BEACON LITE ROAD STOCKPILE

CONSTRUCTION DRAWINGS AMENDMENT

EDARP FILE NO.: CDR261

GRADING & EROSION CONTROL PLAN - FINAL - AMENDMENT

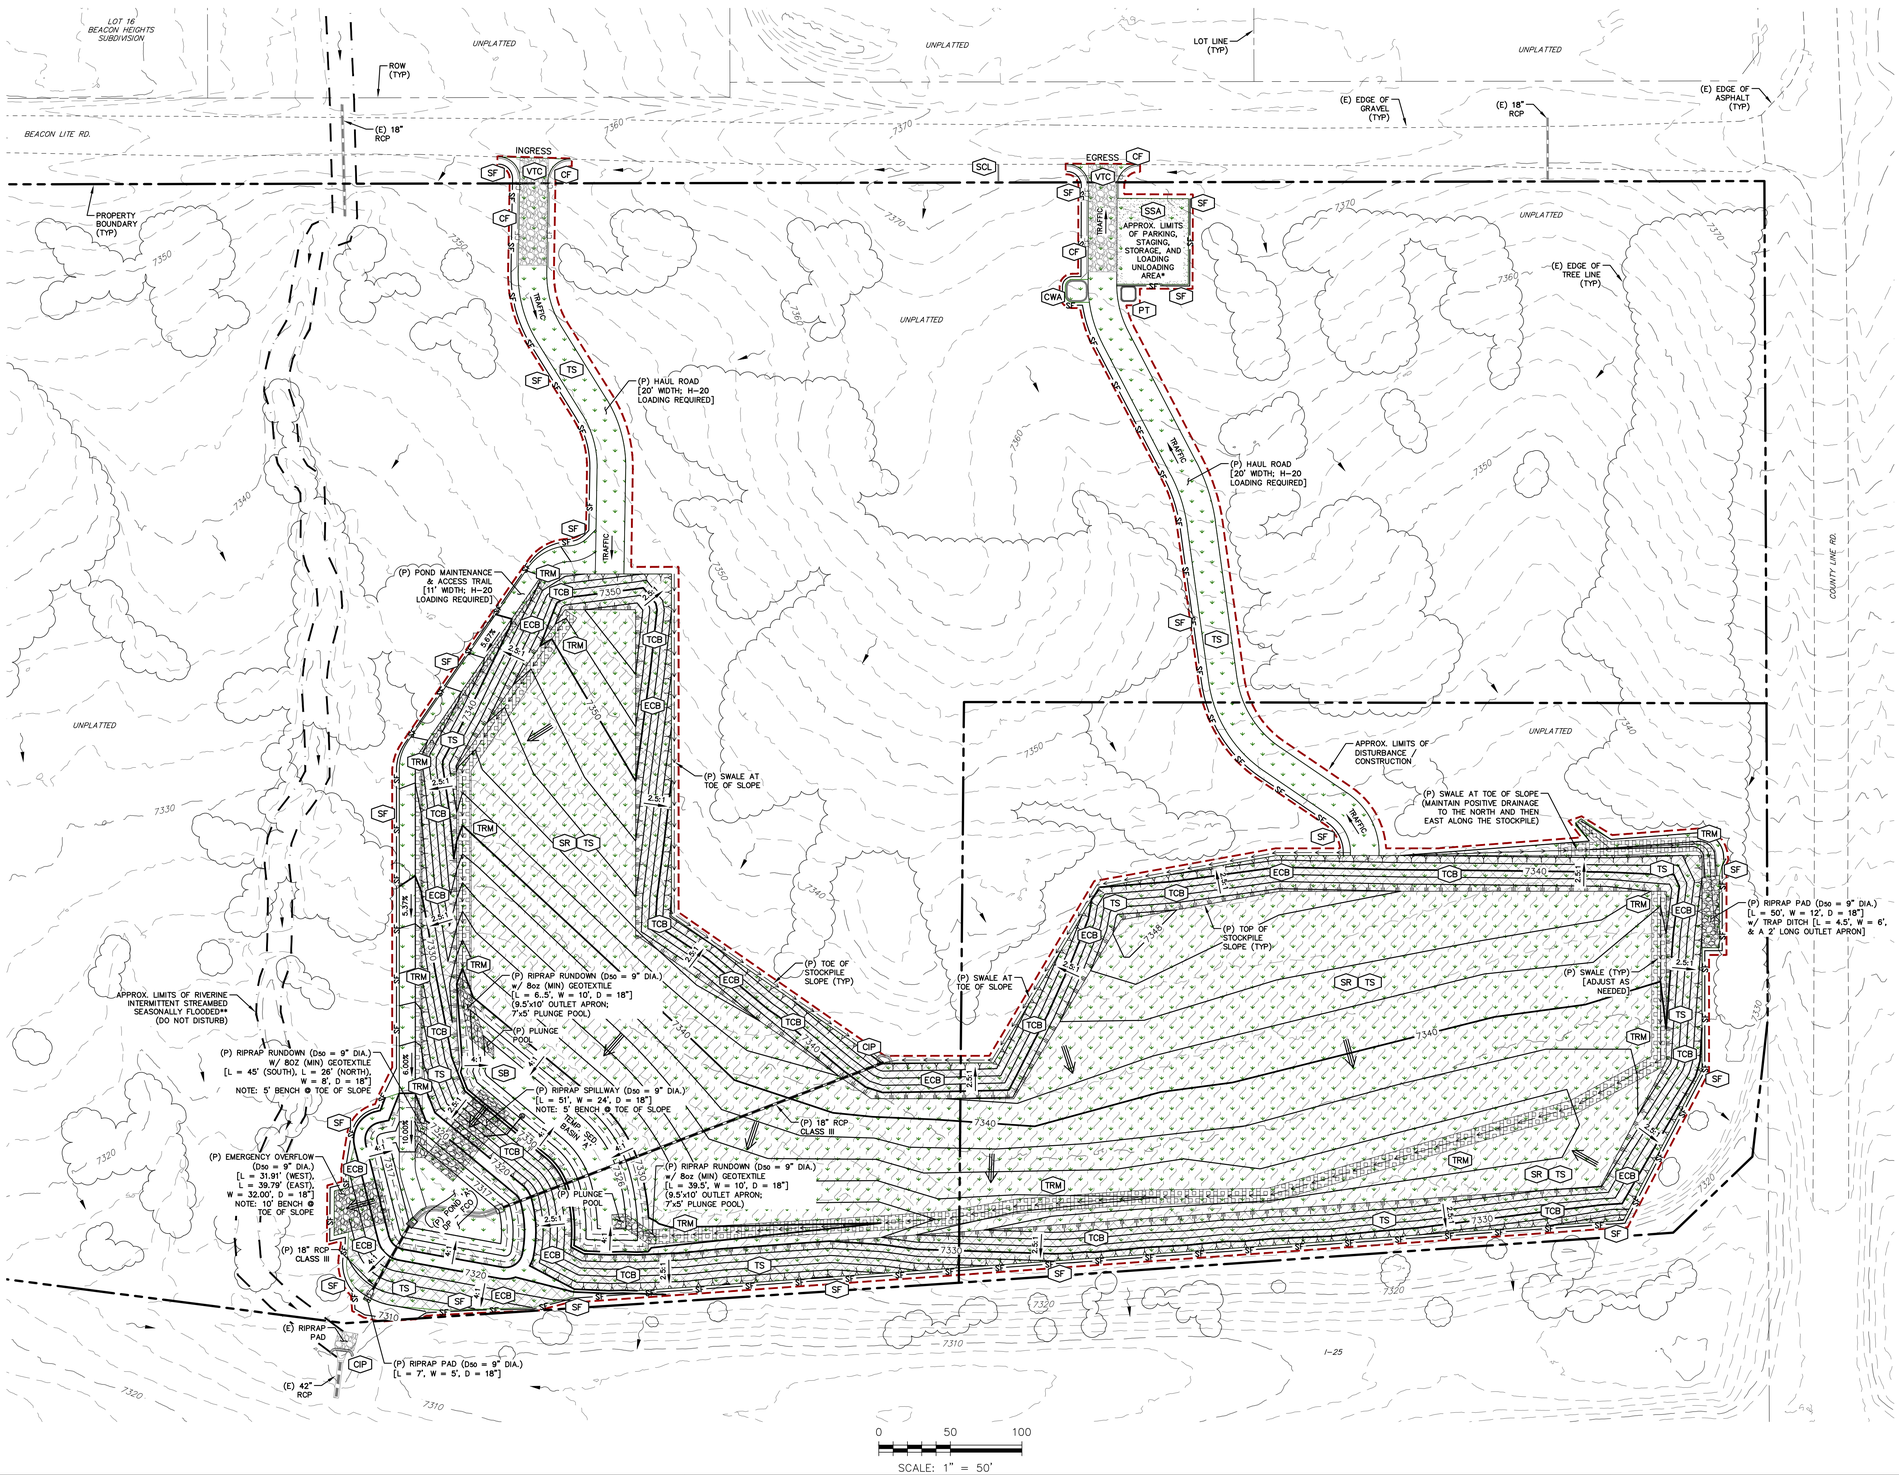
This proposed pond linework does not match what is shown on page 10 below. Page 10 no longer shows both original and proposed. It just shows original. So are you planning to modify this pond or not?

GRADING & EROSION CONTROL PLAN STAGING AREA - AMENDMENT

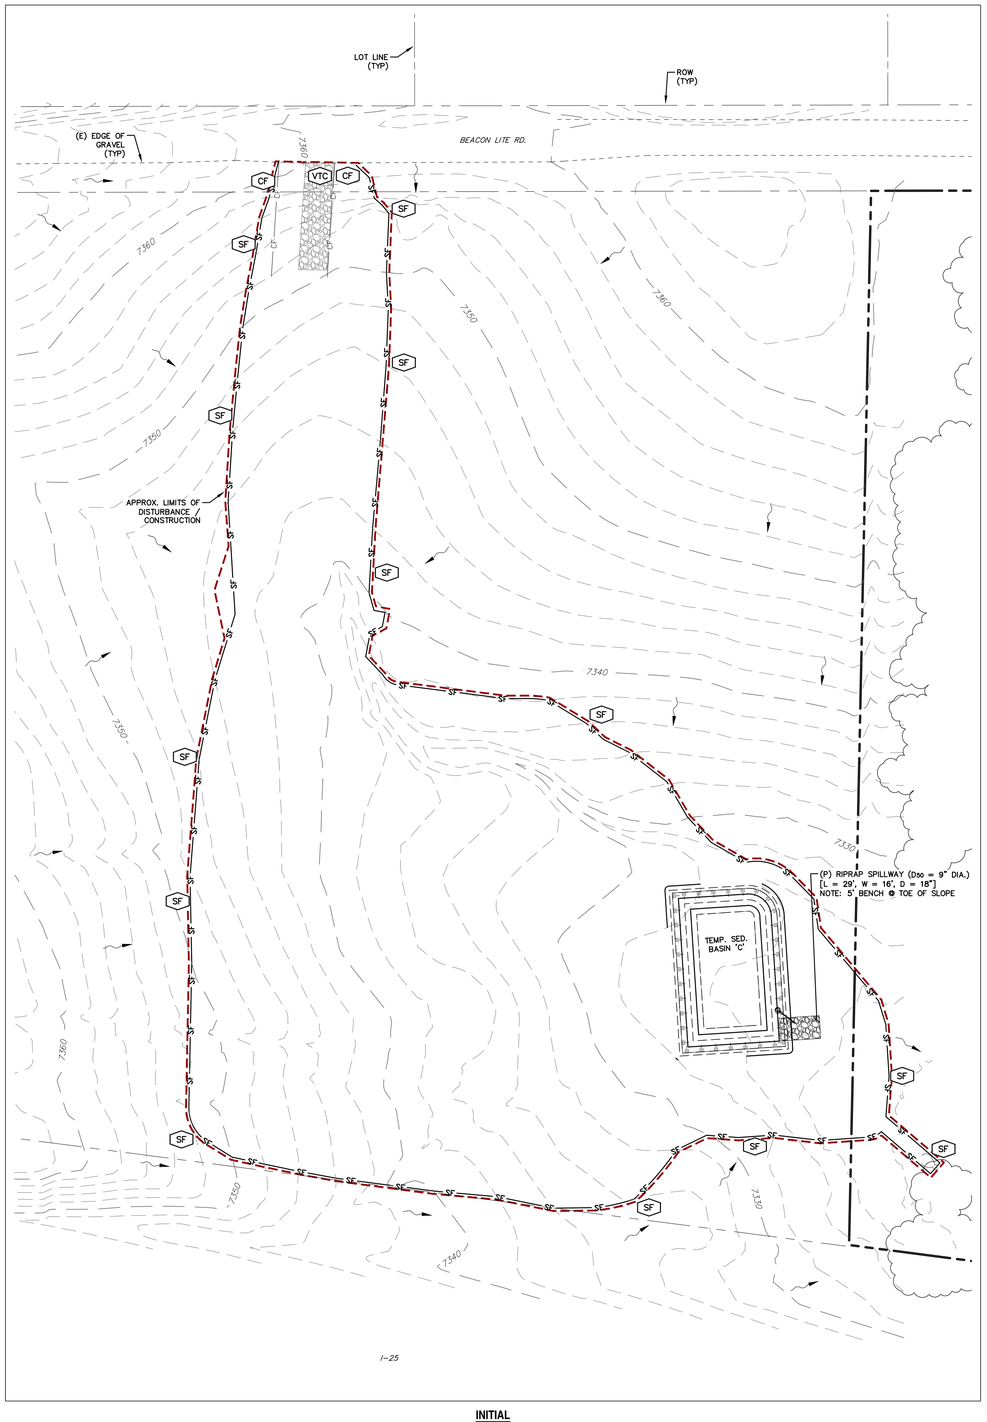
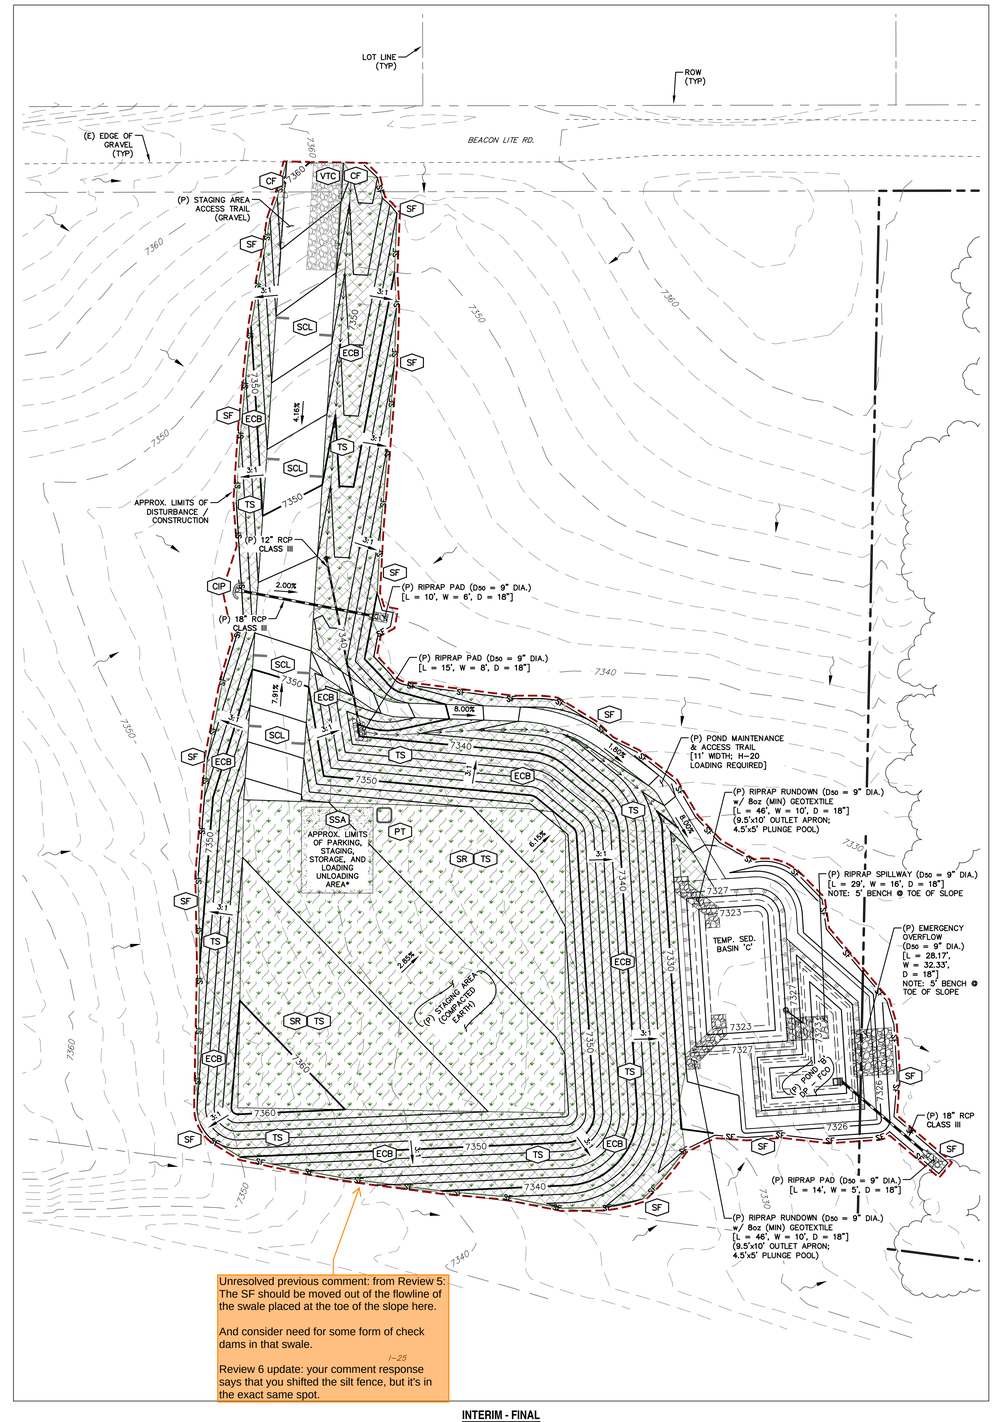
Unresolved previous comment: from Review 5: The SF should be moved out of the flowline of the swale placed at the toe of the slope here.

And consider need for some form of check dams in that swale.

Review 6 update: your comment response says that you shifted the silt fence, but it's in the exact same spot.

SECTION A-A
SCALE: N.T.S.

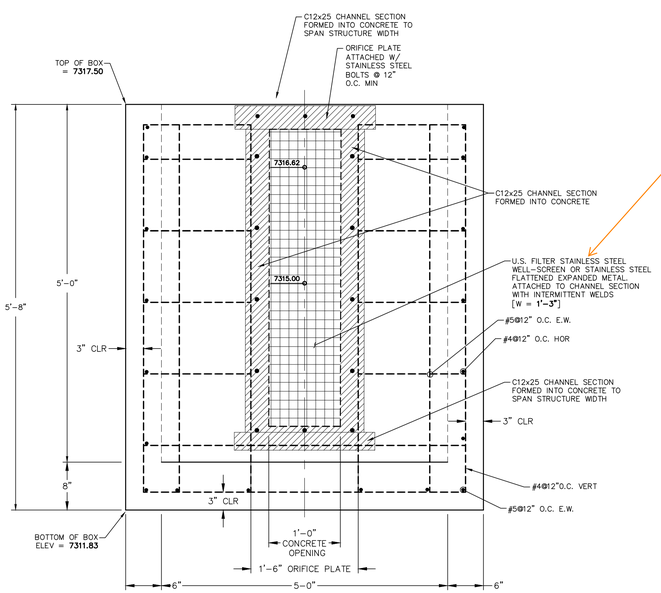
Unresolved comment from Review 5: Flattened expanded metal is not an equivalent alternative to what is in our criteria.

Unresolved comment from Review 5: Revise text for size discrepancy. Calcs and detail in upper left of this sheet show 2.5'x4'

Unresolved comment from Review 5:

Please provide more detailed gasket info like thickness, width, brand/model, etc.

Based on input gathered from industry experts, below is the recommended gasket spec:

The gasket shall be made of 1/4-inch thick, 60 durometer EPDM rubber in a continuous sheet the size of the orifice plate. The sheet shall be placed between the orifice plate and the concrete wall, with the width of the overlap between the plate and the concrete. Openings shall be cut into the sheet corresponding to the plate bolt holes and the concrete wall opening, cuts made either by the contractor in the field or by the manufacturer. Or equivalent gasket approved by EPC. Note that caulk is not an approved equivalent and will not be accepted by EPC.

SECTION A-A
SCALE: N.T.S.

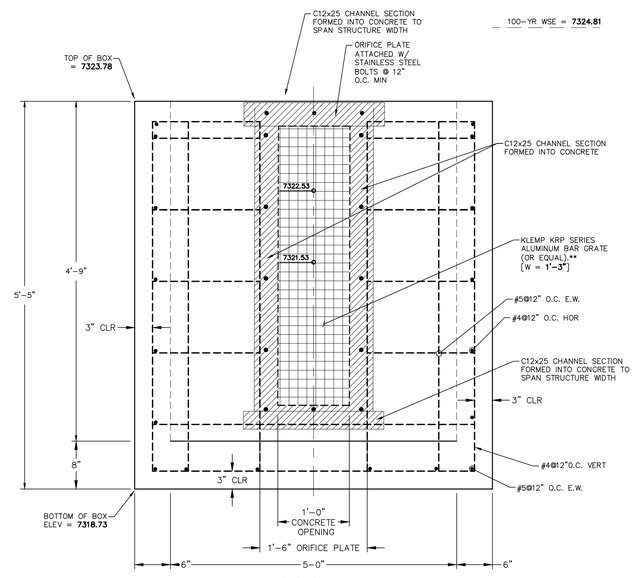
delete "5/16" because the note in the title block below calls for 1/4" thick

it's not a well screen, it's a bar grate. Revise so contractor does not order a well screen.

SECTION B-B
SCALE: N.T.S.

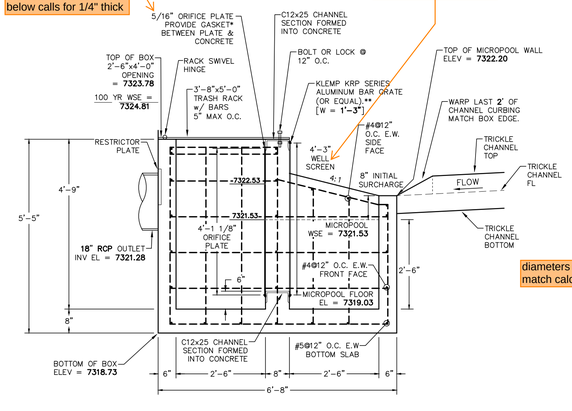
diameters do not match calls
